Re: State Significant Development Application Number SSD-78346486

Build to Rent: 815 Pacific Highway, Chatswood

Request for SEARS

Figure 1: Locality Plan

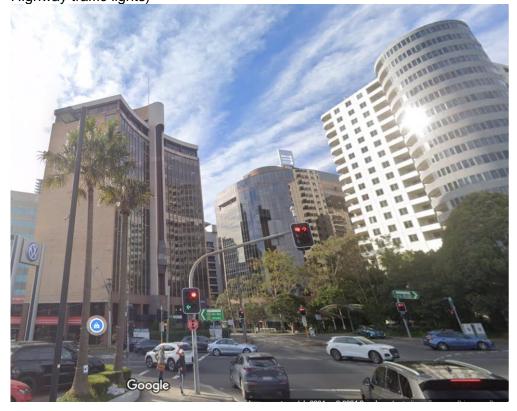
In addition to the above rationale for amalgamation, there is specific need due to the unusual shape and the location of 815 Pacific Highway. While the site has an area of 1,657m², it is irregularly shaped, with:

- The largest frontage being to the Pacific Highway (approximately 60m).
- In regards Help Street, a curved frontage (approximately 30m) leading into a straight frontage (approximately 21m).
- A predominantly curved frontage to McIntosh Street (approximately 9m).

Vehicle access to the site is constricted via McIntosh Street, is not supported via the Pacific Highway (being a State road) and is problematic from Help Street. The site is located on a significant intersection where the Pacific Highway meets Fullers Road from the west and Help Street to the east. Fullers Road is a significant road from the west bringing traffic into the Chatswood CBD via Help Street, and under the Help Street railway bridge into the Chatswood CBD on the eastern side of the North Shore Rail Line.

Figure 2: Site Layout below.

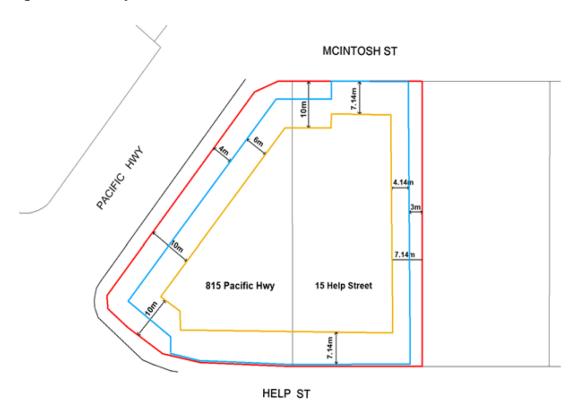
The envelope sought in this concept proposal involves significant variation to expected ground level public domain and tower setbacks. A site specific Development Control Plan for 815 Pacific Highway and 15 Help Street accompanied the made Planning Proposal, which was fully compliant with the CBD Strategy including setbacks and public realm

The SSD application proposes ground setbacks as follows:

- Pacific Highway Podium setback provided at ground level but unspecified.
 Podium above ground level extends to boundary.
- Help Street Setback provided for approximately half of the podium, with the remainder built to boundary.
 Podium above ground level extends to boundary.
- McIntosh Street Podium setback provided but unspecified.
- 15 Help Street No setback provided.

The SSD application proposes tower setbacks as follows:

- No setback to the majority of the Pacific Highway boundary to approximately RL 280m (175m).
- Help Street No setback provided to approximately R 280m (175m).
- McIntosh Street Unspecified setback.
- 15 Help Street Unspecified setback provided.

In Council's view, SEARs should not be issued until amendments are made. Any development of the site should address the objectives of the WDCP, in particular amendments should provide more appropriate setbacks and improve podium design and ensure a slender tower form. Amendments should ensure the proposal maintains a consistent setback on the Pacific Highway with neighbouring sites, and delivers the required pedestrian and public domain outcomes.
